UNITED STATES PATENT AND TRADEMARK OFFICE

APPLICATION NO.	FILING DATE	FIRST NAMED INVENTOR	ATTORNEY DOCKET NO.	CONFIRMATION NO.
10/070,577	07/09/2002	Jordi Galan I Llongueras	8000-21	7171

Office Action Summary

DETAILED ACTION***Drawings***

FIG. 7

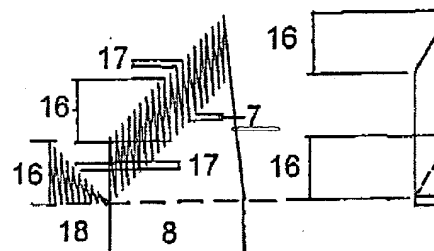
Figure 7 contains two separate figures, which should be identified as such in the Drawings and in the Specification.

Figures 6 and 7 contain foreign language.

Figure 7, detail "7" shown below should read --17--.

FIG. 6

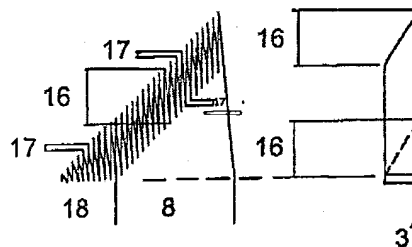
Figure 6 contains two separate figures, which should be identified as such in the Drawings and in the Specification.

Figure 6, detail "17" shown below should be the same font so as to be visible.
